INSPECTION DEPARTMENT
Combe plate weekly survey sheet
DATE. 2015.10.09..

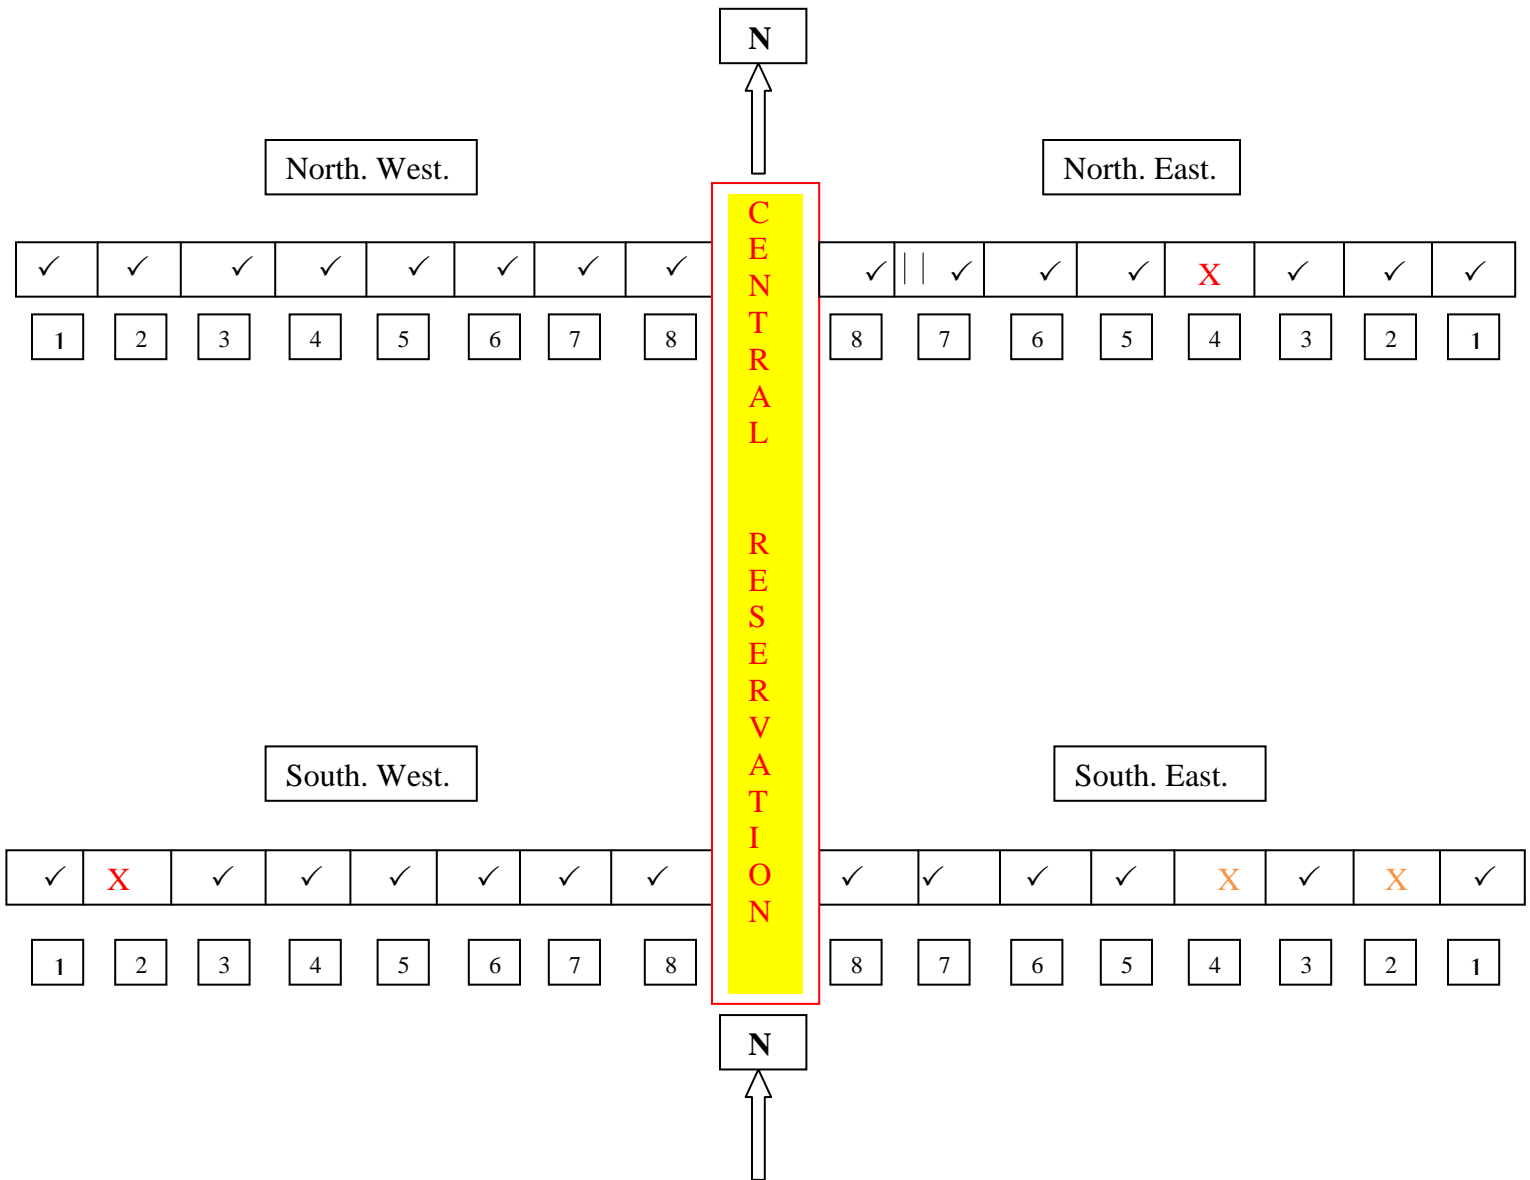
On the southbound carriageway NE combe plate No 4. Very noisy now , Banging when heavy vehicles pass over .Requires attention.

On the Southbound Carriageway SE4 – slight movement/ slight noise evident when heavy vehicles pass over – will monitor
 Southbound Carriageway SE2 – there is slight movement / slight noise evident – will monitor. Plates noisier on this inspection will require attention soon.

On the Northbound Carriageway (West Side) SW1 – repairs carried out 26.08.15 by Engineers
 Northbound Carriageway SW2 – there is movement/ noise evident.
